**CITY OF TACOMA
TACOMA POWER**

ADDENDUM NO. 1

Request for Bids Specification No. PG21-0045F

Mayfield Water System Replacement and Road Realignment

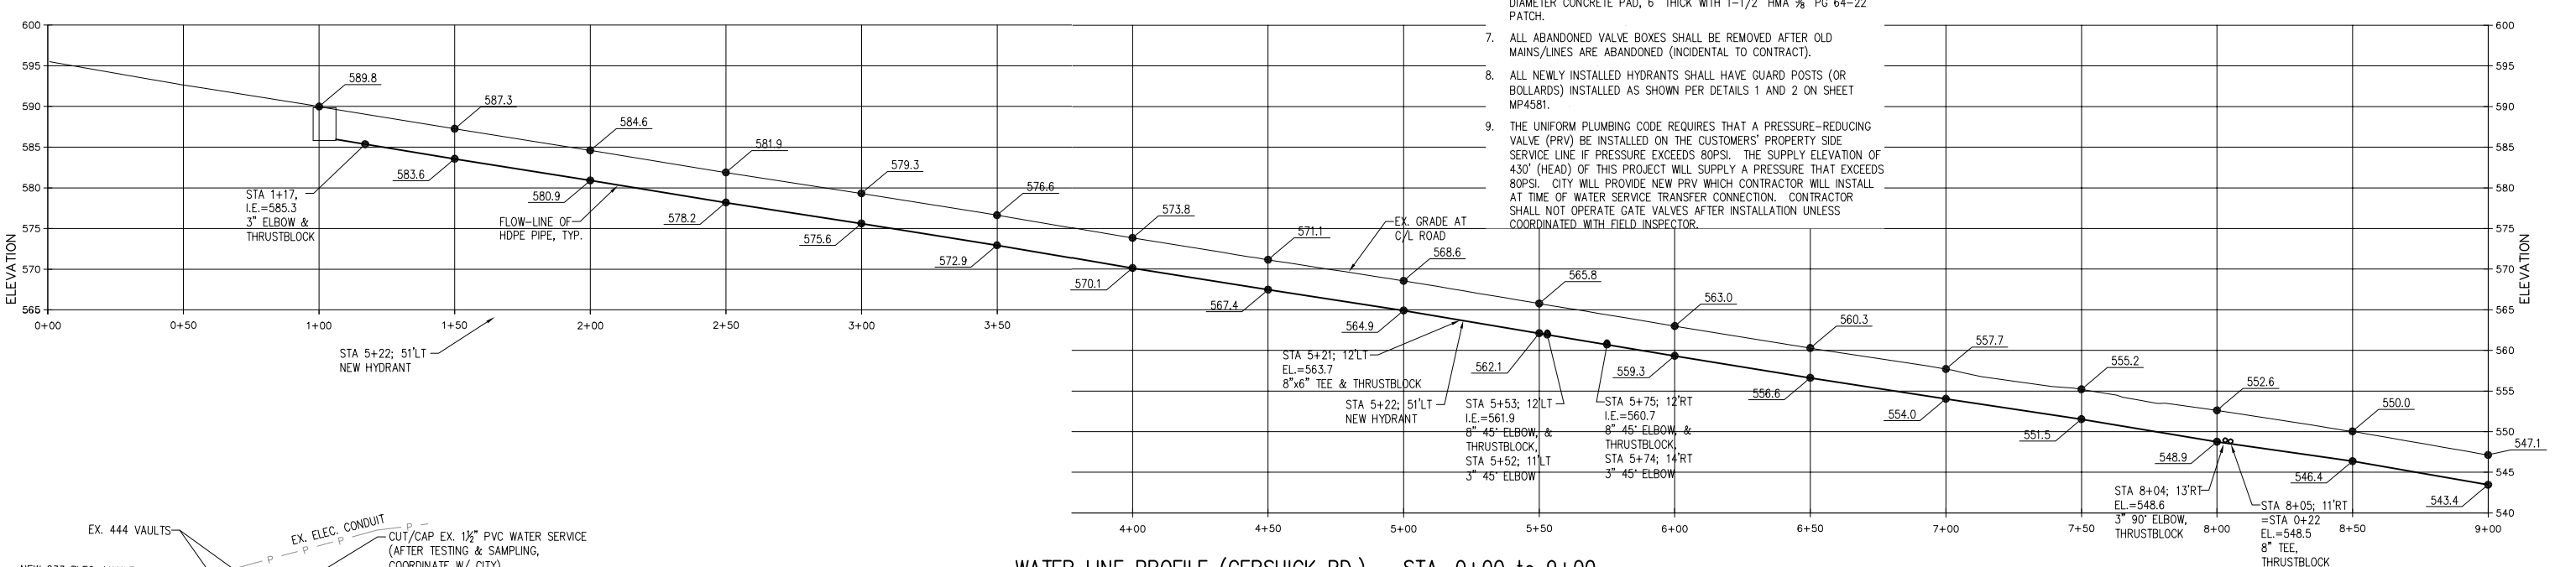
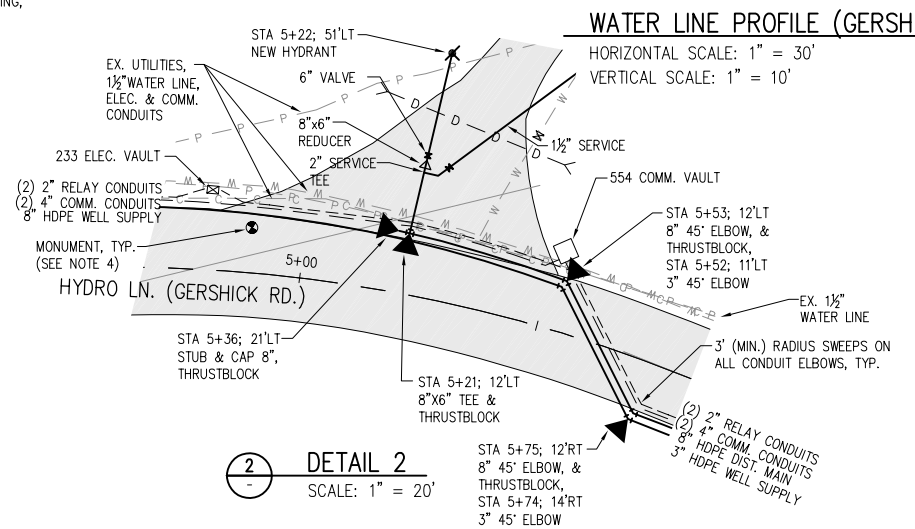
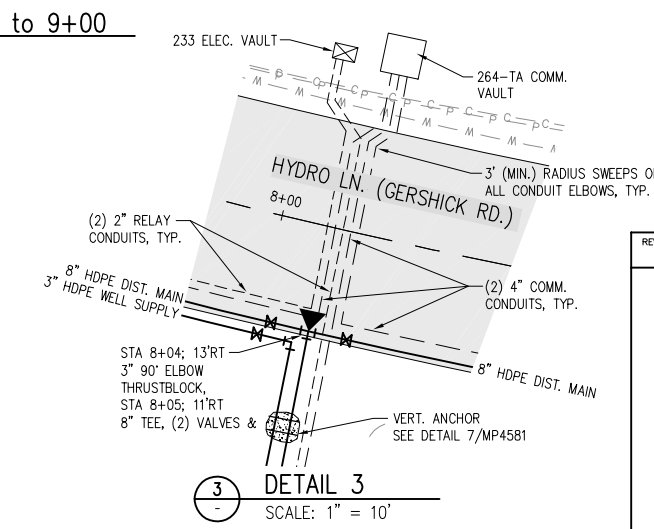
- 1) Replace Drawing MP1561 with drawing provided with addendum.
- 2) Replace Drawing MP4566 with drawing provided with addendum.
- 3) Remove Drawing MP4572-**B** from specification (NOTE: Retain Drawing MP4572).
